ADDENDUM NO. 1

**AGAWAM-WEST SPRINGFIELD**

**Federal Aid Project Nos. NHP(BR-ON)-003S(070) & STP(BR-ON)-003S(070)  
Bridge Replacement Br. No. A-05-002=W-21-014 (Steel)  
Route 147 (Memorial Avenue) over the Westfield River and  
Intersection Improvements (Including Signals) at 3 Locations along Route 147**

**Responses to Bidder's Questions**

STATE	FED. AID PROJ. NO.	SHEET NO.	TOTAL SHEETS
MA	NHP(BR-ON)/STP-003S(070)	95	296
PROJECT FILE NO.		605384

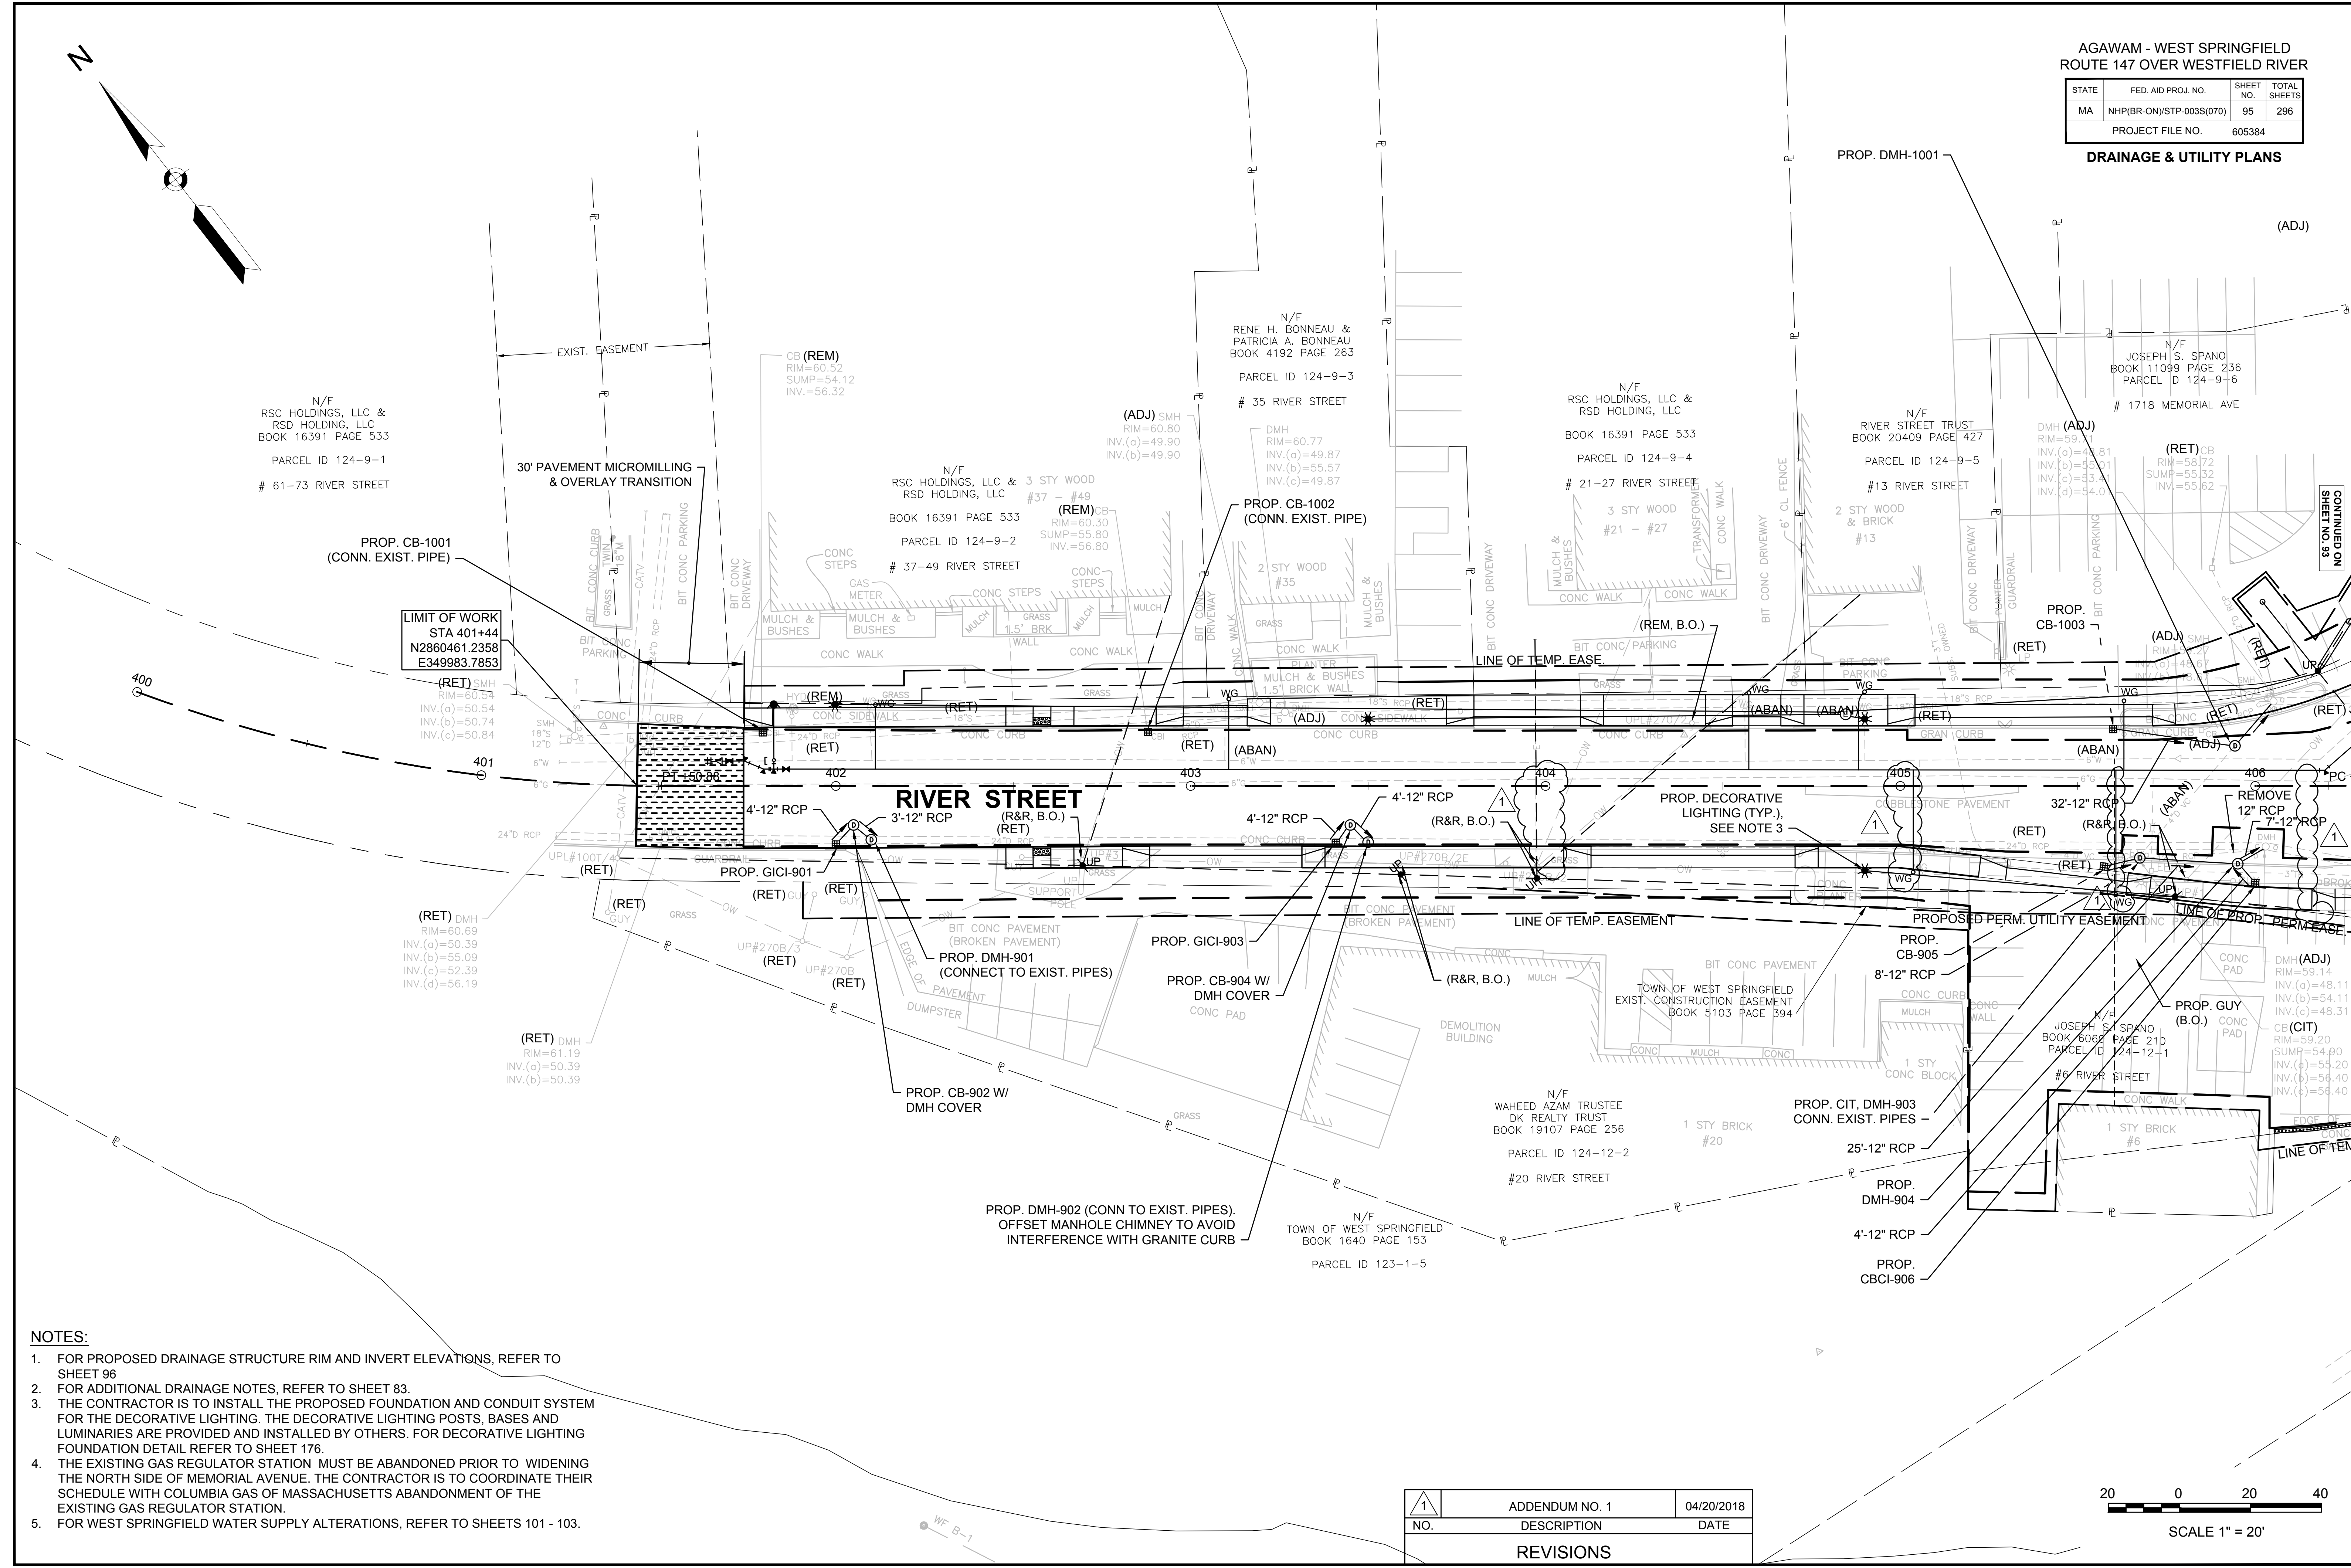
Question 2) In reference to sheet 101 of 296 at stations 405+10 & 405+61 there are two temporary water services on the south side of River Street. Will new permanent services be required at these location? If so please provide details for the permanent tie ins.

Response 2) See revised drawings 95 and 101 of 296 (attached).  
Permanent tie in details are shown on sheet 104 of 296.  
See revised page A00801 – 83.
